Service Bulletin

SERVICE BULLETIN LIST

Subject: Bosch/N.G.K. Spark Plug
Conversion Chart

Subject: Armature plate replacement part

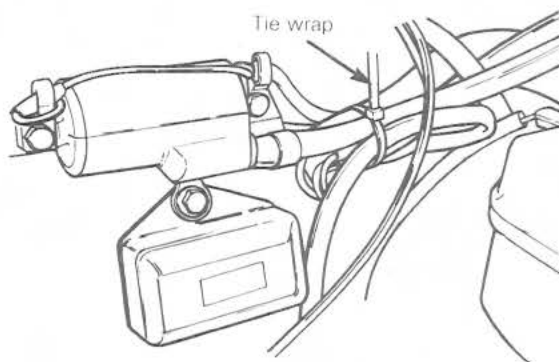
The wires of the replacement part armature plate assembly (P/N 420 866 650) for above listed models will be longer than on the original part on the vehicle.

When installing this replacement part, secure the wiring using a tie wrap, as illustrated.

This will avoid loose wires from touching moving or rotating parts.

Subject: Engine retaining bracket ass'y

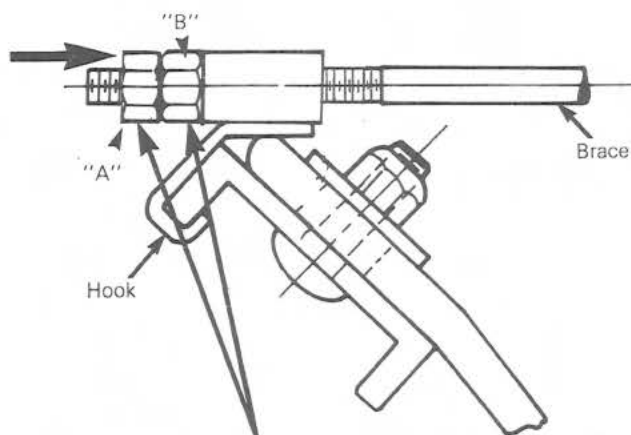
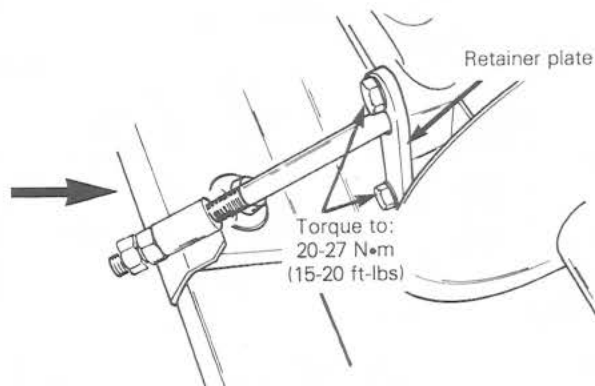
The 1982 Blizzard 9500 & Ultra Sonic are equipped with an engine retaining bracket ass'y. This feature will add extra life to the drive belt by preventing the engine from twisting upon acceleration.

- Install the hook weldment to the engine support.
- Install the retainer plate to the engine crankcase electric starter location. Secure it using the two (2) screws and lockwashers. Torque to 20-27 N•m (15-20 ft-lbs).

- Install the 90° brace end to the retainer plate and the other end to the hook. Secure it using the two (2) nuts.

- 1) After pulley alignment, torque nut "B" to 4-5 N•m (3-4 ft-lbs).
- 2) Holding nut "B" torque nut "A" to 20-27 N•m (15-20 ft-lbs).
- 3) Reverify pulley alignment.

Subject: Engine retaining bracket ass'y

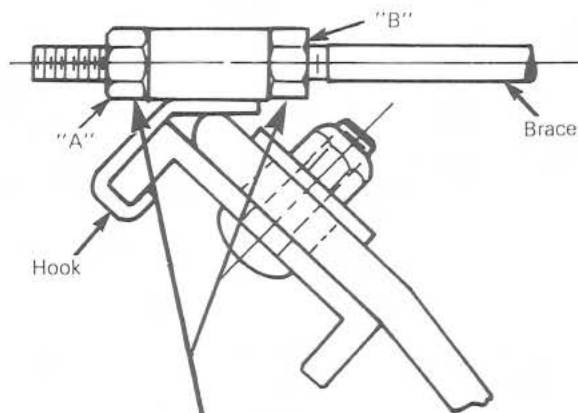
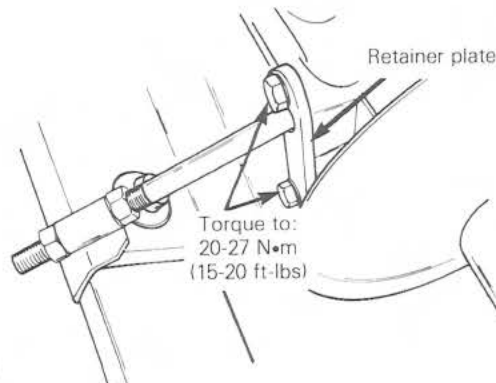
- Install the hook weldment to the engine support.
- Install the retainer plate to the engine crankcase electric starter location. Secure it using the two (2) screws and lockwashers. Torque to 20-27 N•m (15-20 ft-lbs).

- Install the 90° brace end to the retainer plate and the other end to the hook. Secure it using the two (2) nuts.

- 1) After pulley alignment, torque nut "A" to 4-5 N•m (3-4 ft-lbs).
- 2) Torque nut "B" to 20-27 N•m (15-20 ft-lbs).
- 3) Reverify pulley alignment.

Subject: Removal of Skandic hood grills

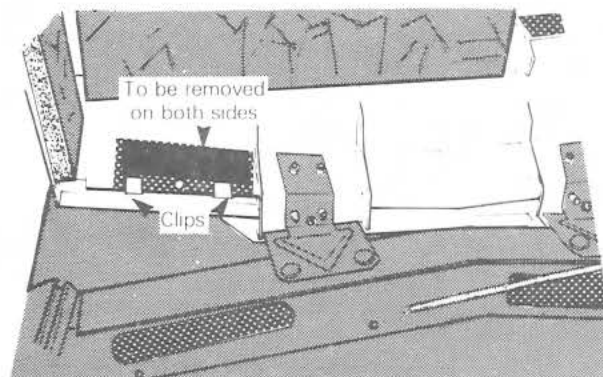
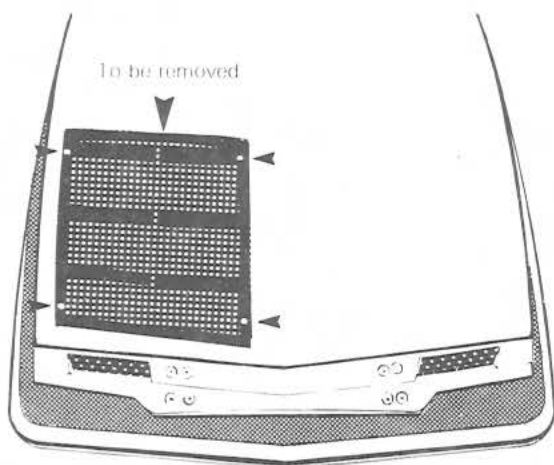
The 1982 Skandic has been equipped with snow deflector grills on the hood to prevent snow from entering the engine compartment. However, under certain warmer temperatures, springtime as an example, these grills may be removed. This will enable the engine to run cooler.

Using a small Philips screwdriver, remove the four screws holding the upper grill (P/N 517 1477 00) in position.

Remove the four clips holding the two lower grills (P/N 517 1478 00) in position.

Subject: Battery installation

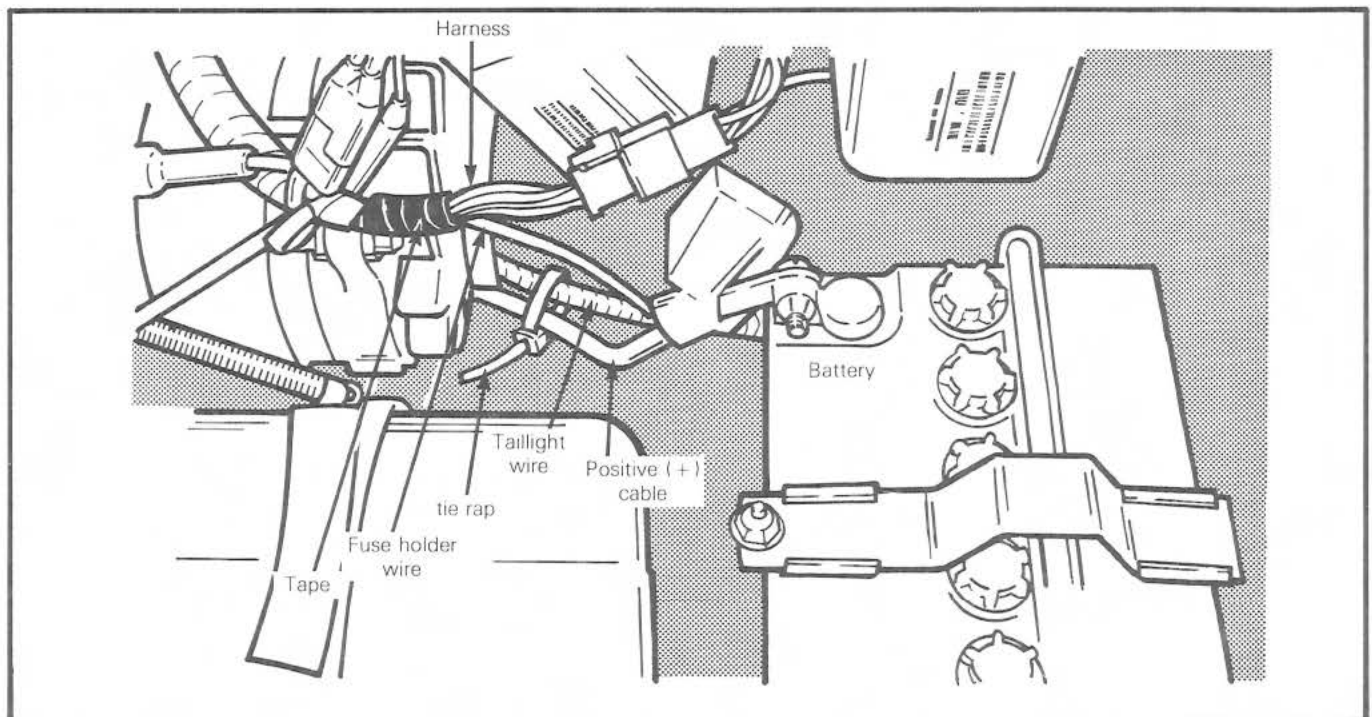
After charging the battery and reinstalling it on the vehicle, particularly during pre-delivery operations, it is important that the positive (+) cable, the fuse holder wire and the taillight wiring be isolated from the alternator pulley and belt. Wiring and/or cable contact with these rotating parts could cause an electrical short.

To isolate the wires and cable, ensure that the battery positive (+) cable is directed down toward the frame. Particular attention should be made when tightening the cable to the battery post. The fuse holder wire should be taped to the harness. The taillight wiring must be secured to the positive (+) cable using a tie rap. Refer to the following illustration.

Subject: Hitch bracket reinforcement tip

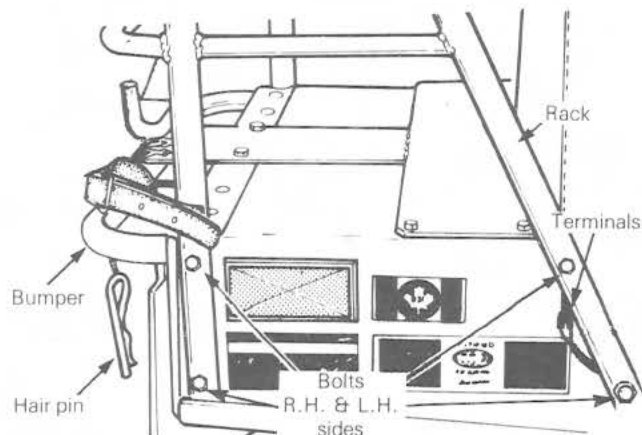
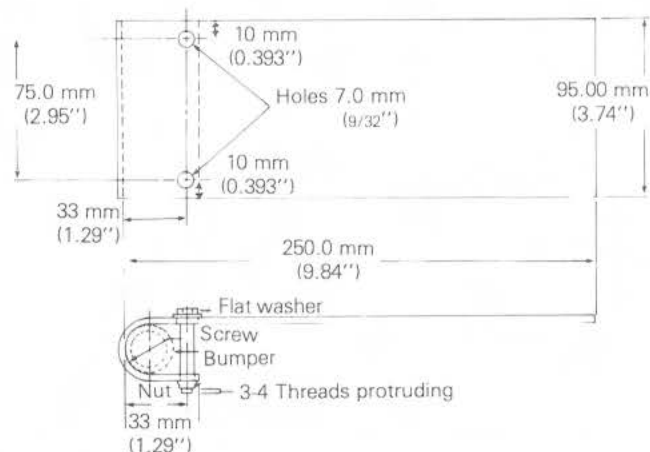
Under heavy load pulling conditions over rough terrain, there is a possibility that the trailer hitch bend. It is suggested that on machines used in these conditions two bolts be installed to lock the hitch securely to the bumper.

- Remove hair pin from the hitch.
- (Skandic models) as illustrated,
Remove the eight (8) nuts and screws securing the rack to the frame.
- Unplug the tail lamp wiring terminals.
- Remove the rack.
- To install, reverse removal procedure.

- Center punch the hitch plate.
- Make the holes using a 7.0 mm (9/32") drill.
- Install the screws, washers and nuts then tighten leaving 3-4 threads protrude through the nuts.

Subject: Carburetors adjustment

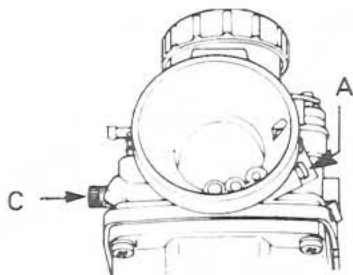
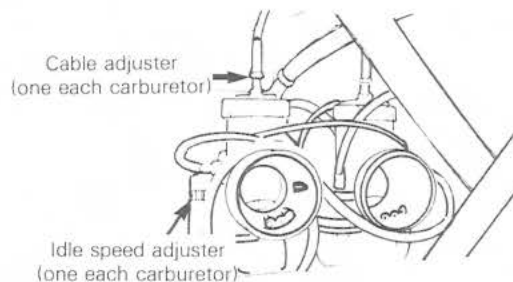
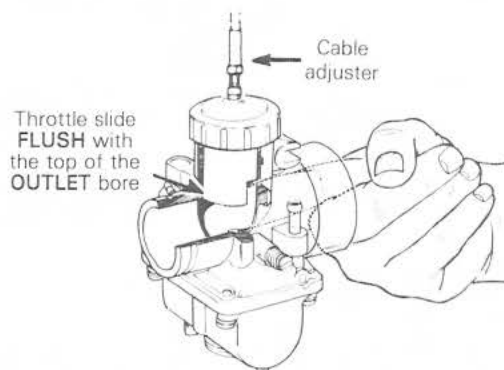
Turn the idle speed screw clockwise until it contacts the throttle slide then continue turning two (2) additional turns. Repeat on the other carburetor. This will ensure identical throttle slide idle setting.

With the throttle cable adjuster jam nuts unlocked, fully DEPRESS the throttle lever and check to have the throttle **FLUSH** with the top of the carburetor **OUTLET** bore. To adjust, turn the carburetor cable adjuster, clockwise or counter-clockwise.

Once both carburetors are adjusted, check that with the throttle lever fully depressed, there is a free play of 1.5 mm (1/16") between the cover and throttle slide. Readjust accordingly.
